NOTICE OF PROJECT CHANGE

15 Necco Street

5 and 15 Necco Street, Boston MA 02210

**Re: Notice of Project Change
15 Necco Street
Boston, MA**

Figure 2.2
Comparative Building Section

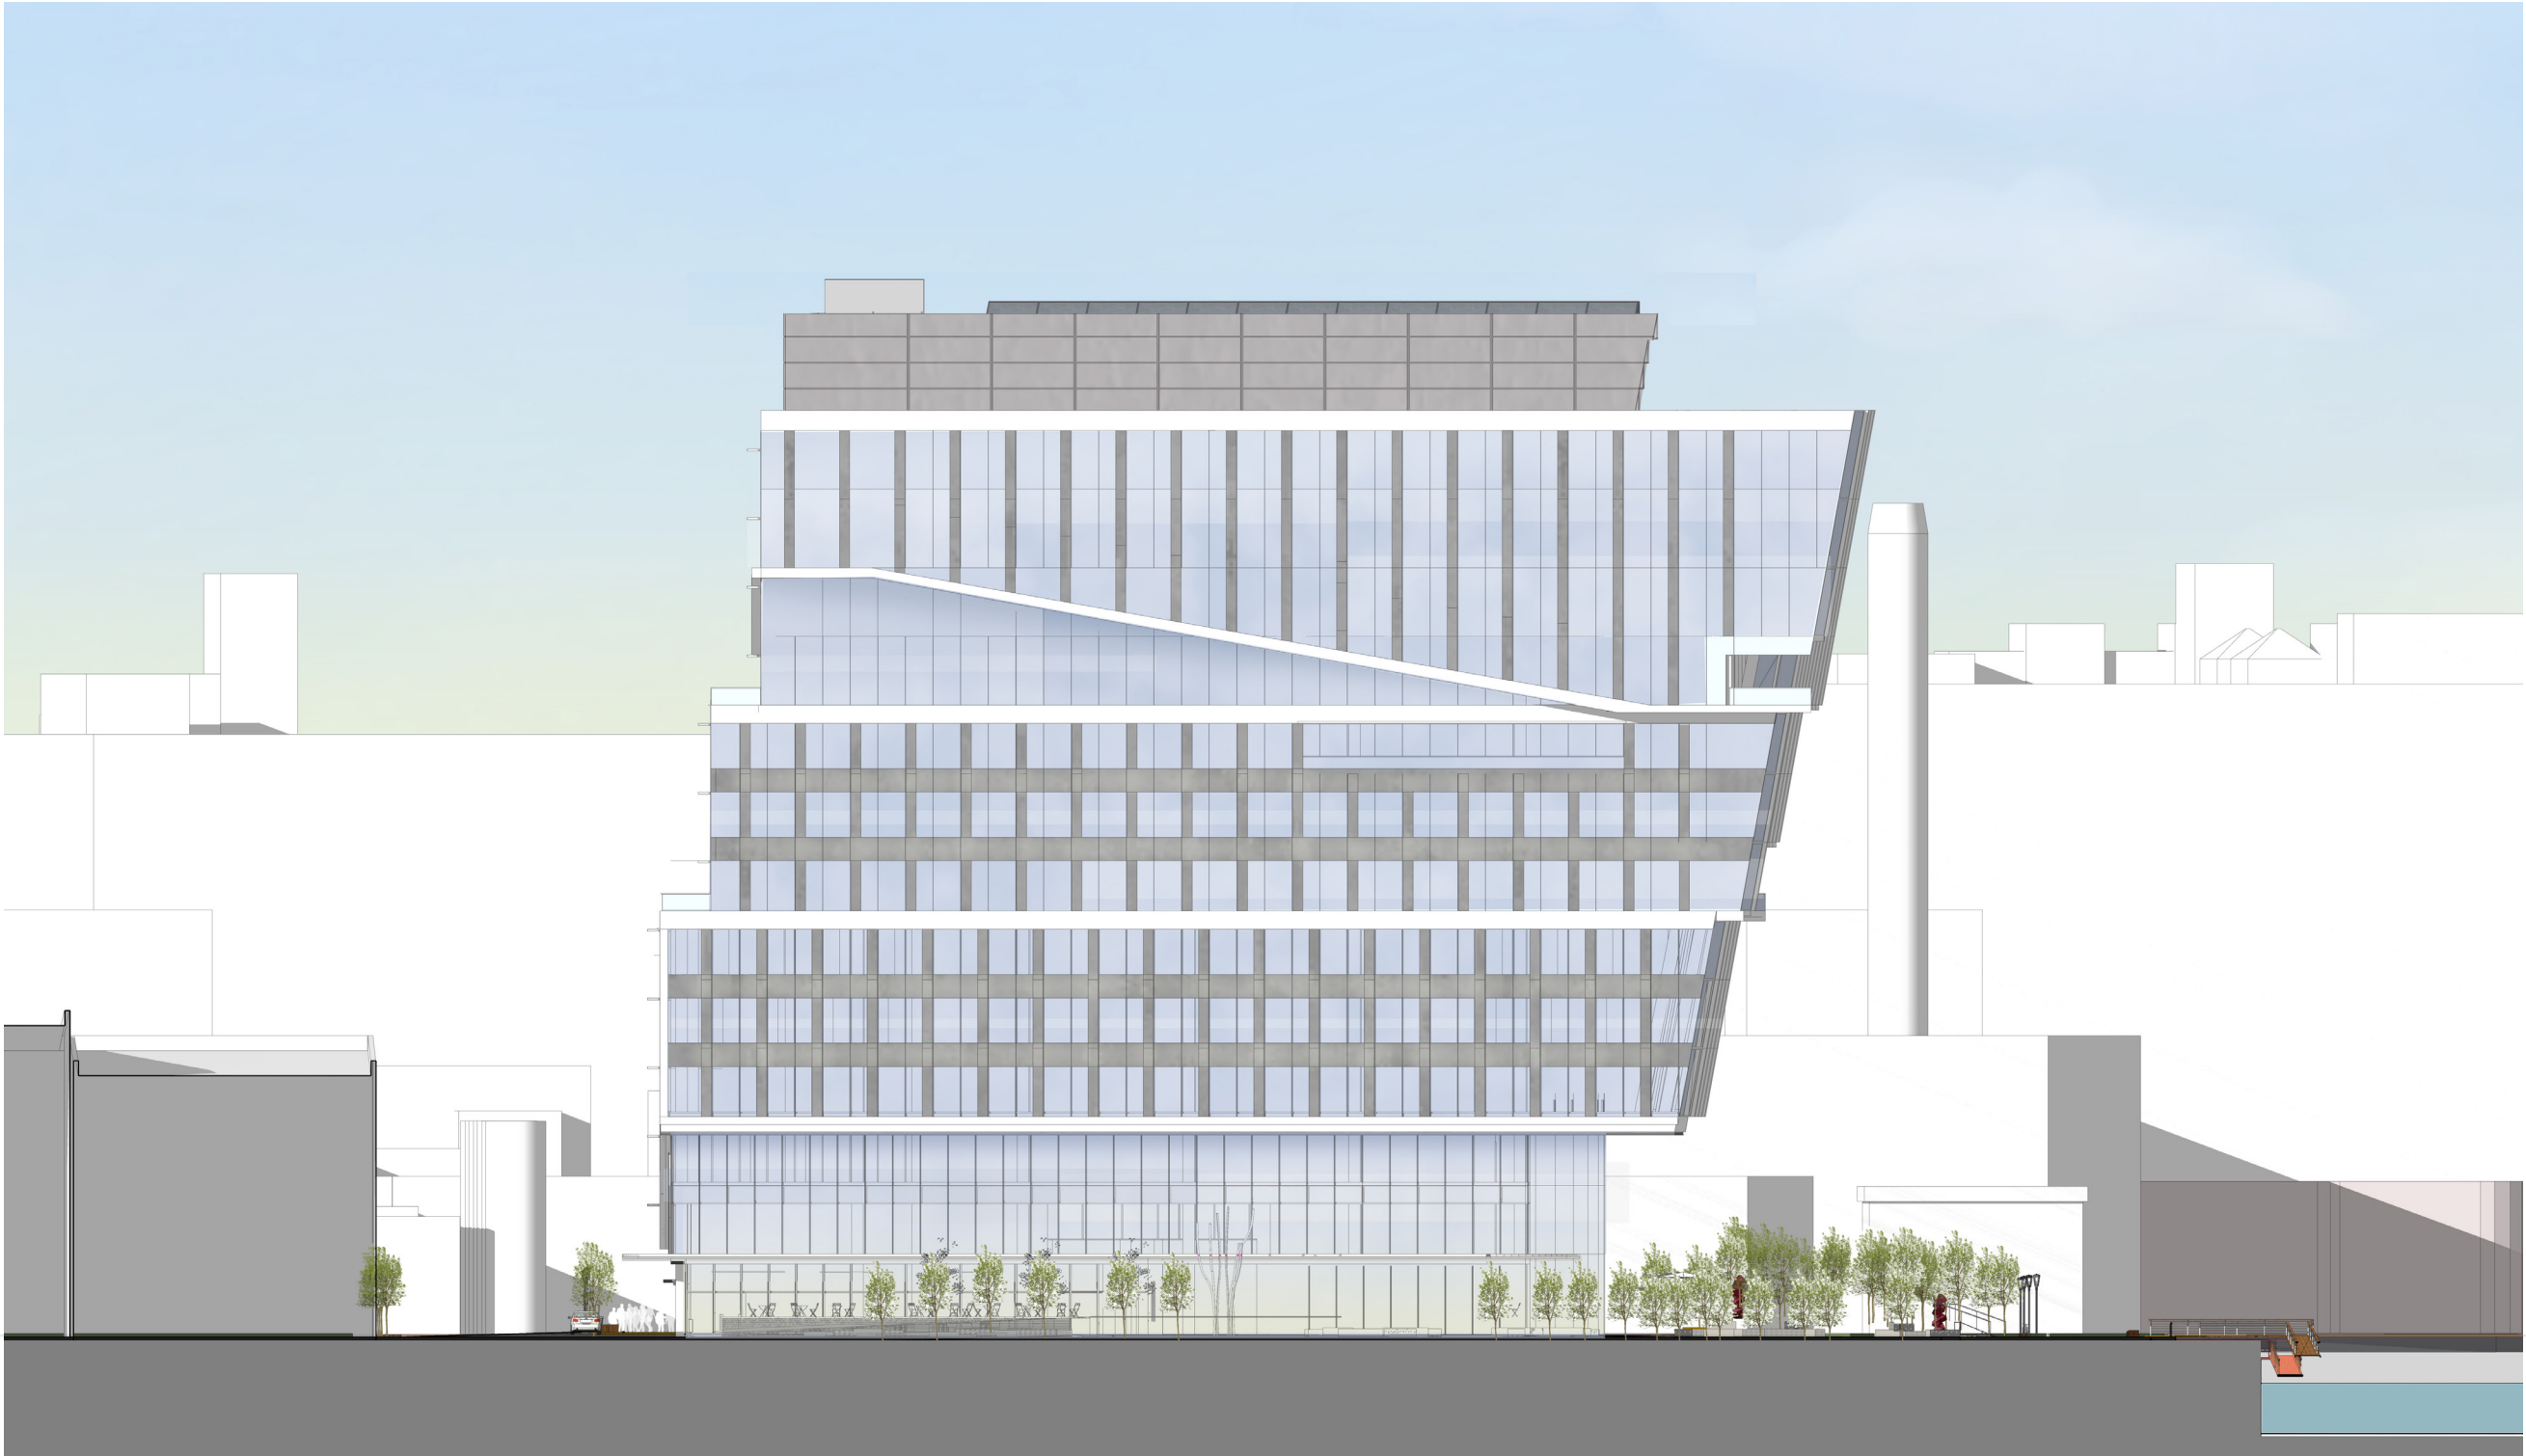
Figure 2.2 presents a comparative massing diagram. The New Building is approximately 173 feet in height (up to 12 stories) to the top of the highest occupiable floor, which is below the maximum zoning height of 180 feet. Similar to the previously approved project, the massing of the New Building is rectilinear in form and conforms to requirements outlined in the 2009 South Boston MHP. To differentiate the New Building from the GE Project, the massing acknowledges the watershed on the western facade and the City across the Fort Point Channel, announcing the Proposed Project and the 100 Acres neighborhood, and welcoming the public. At Necco Street the upper floors of the New Building have been stepped back and planned ground floor uses will increase activity and invite pedestrians to engage and permeate the participate in the amenities offered by the New Building and the Project Site, and to better relate to future planned public open space to the south of the Project Site.

Figure 2.7
Project Change (New Building)
Proposed Landscape Plan
15 Necco Street Project
Boston, Massachusetts

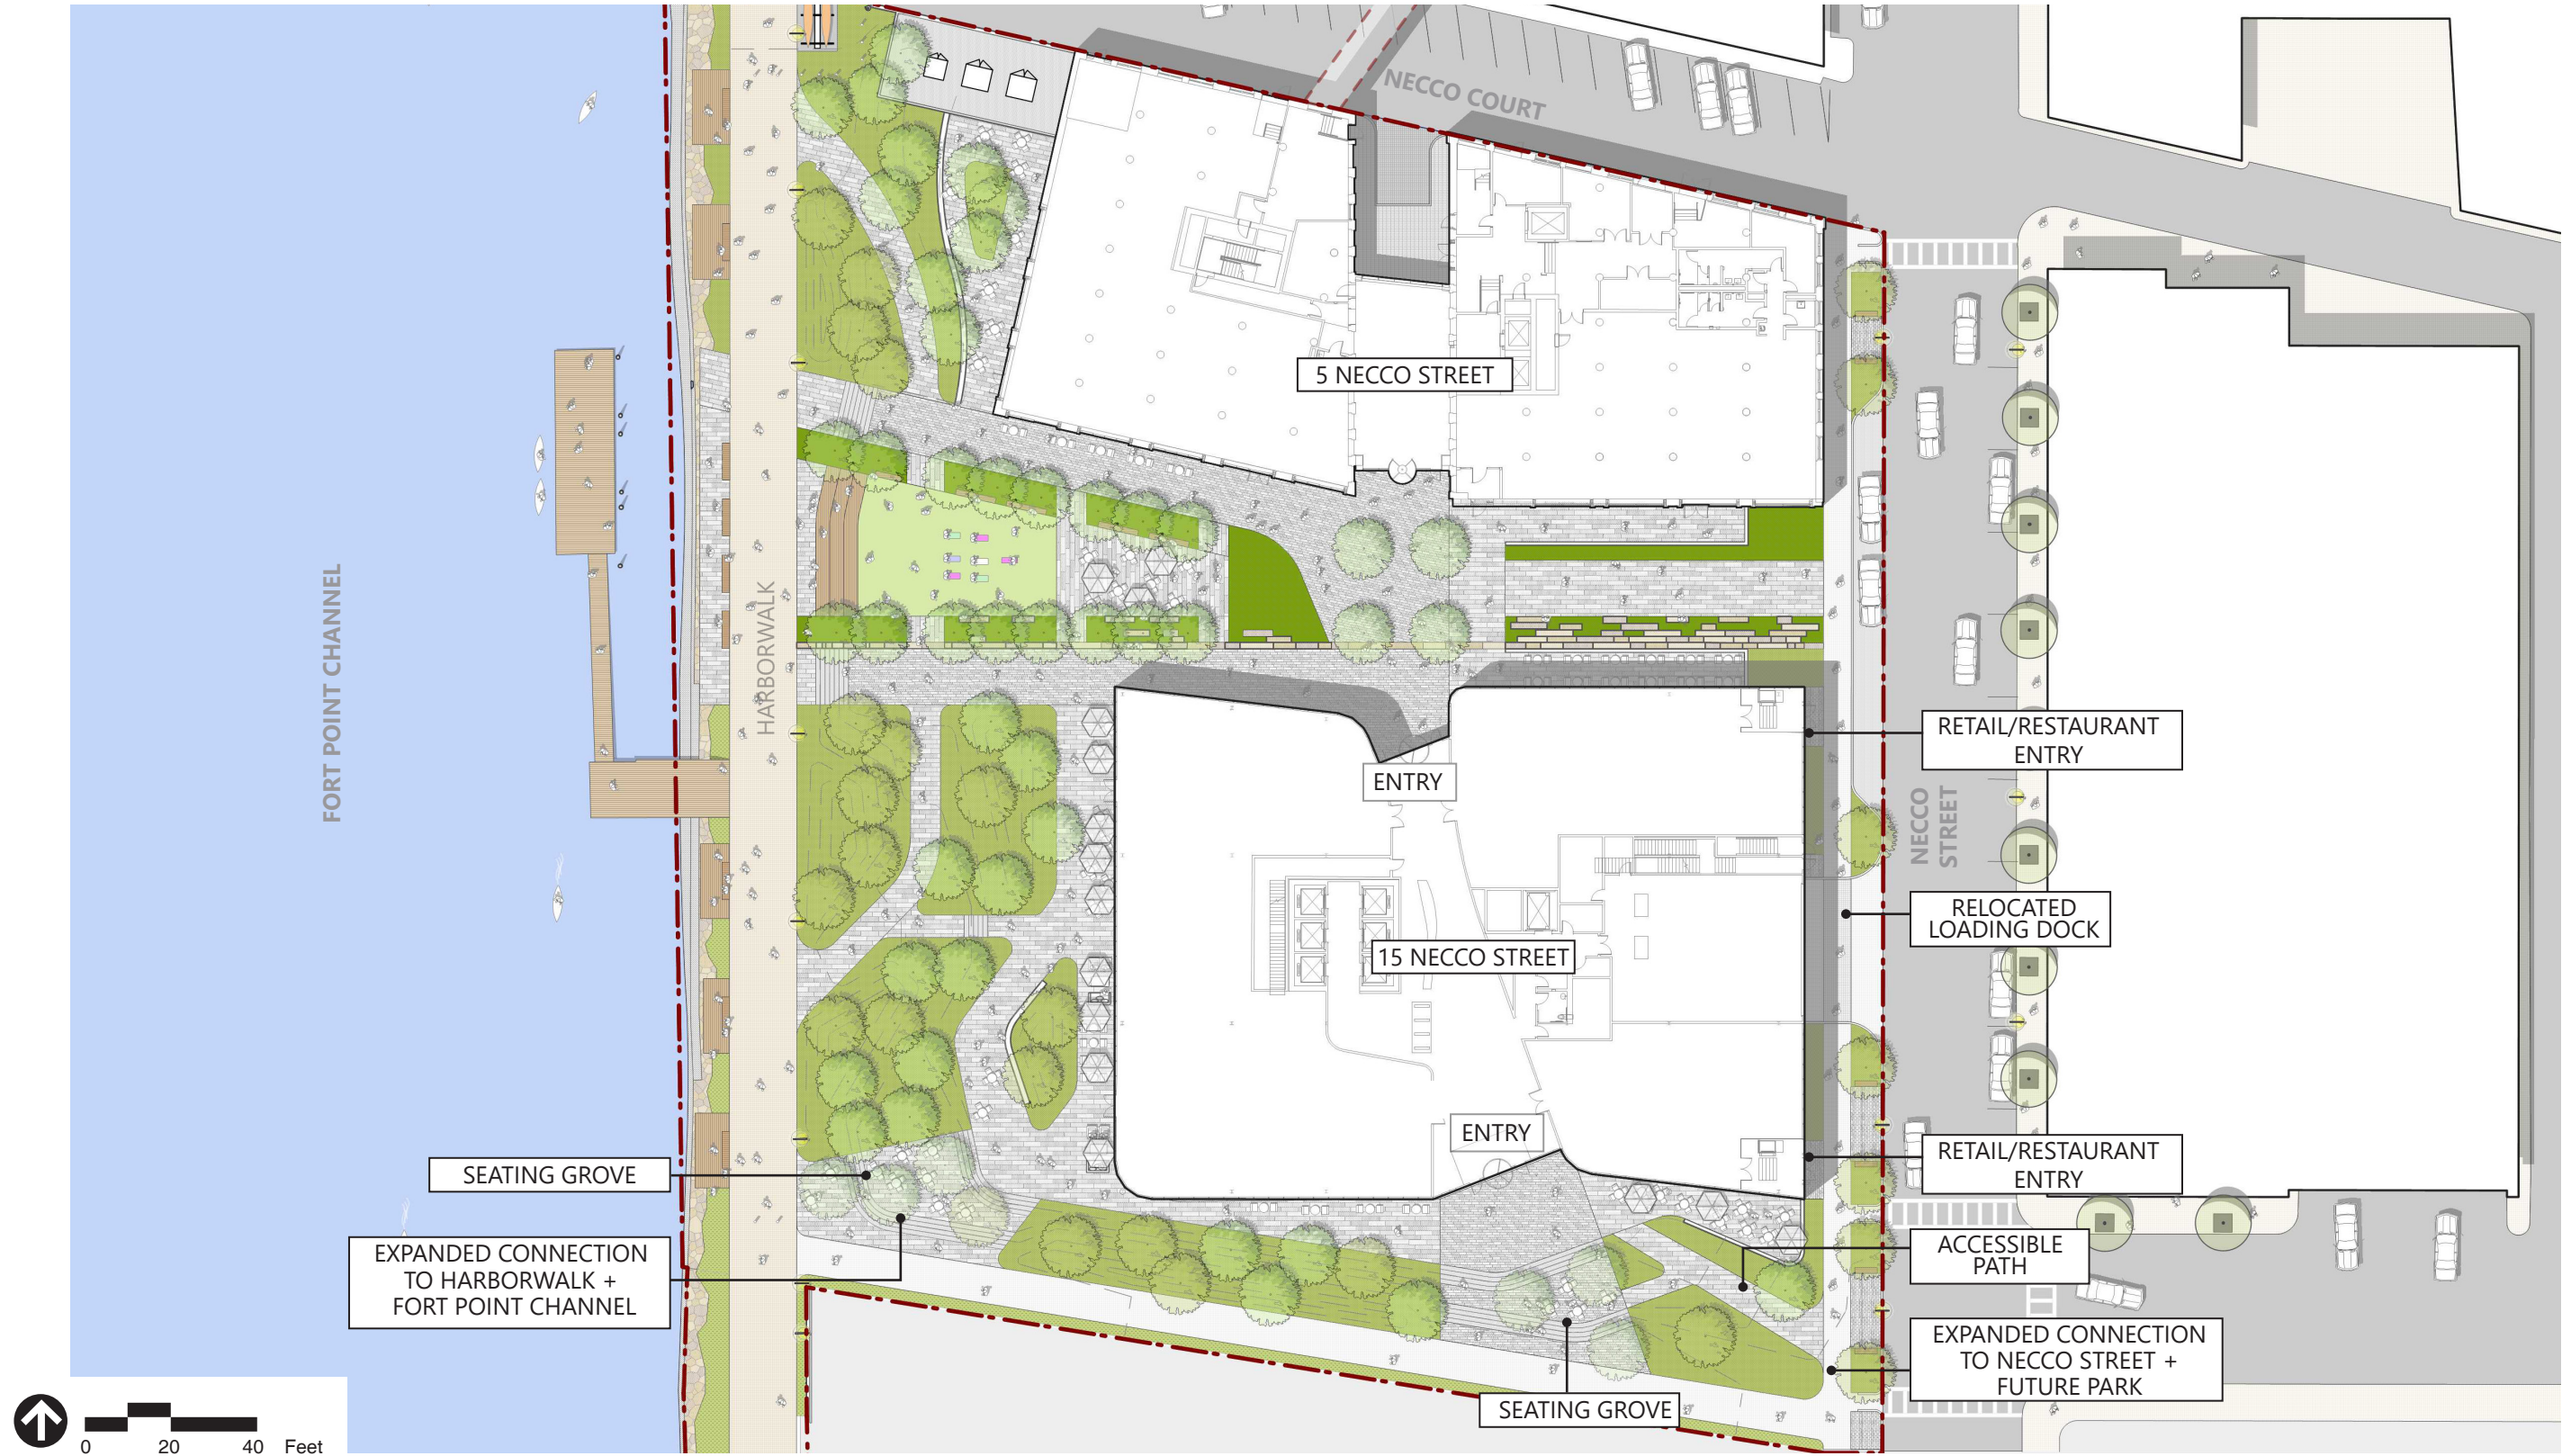
Figure 2.7 presents the proposed landscape and public realm improvements planned for the Proposed Project. Figures 2.8a-c present detailed plans for the proposed public realm improvements, which are substantially similar to those in the previously approved project. Beyond the waterfront improvements, the Proposed Project will provide spaces for public engagement, which may include public art installations, activities and other amenities. The public realm will continue to serve as a showcase for sustainable technology as part of stormwater collection and treatment. Native plantings will serve aesthetic and ecological functions, working to create an environment welcoming of both people and wildlife.
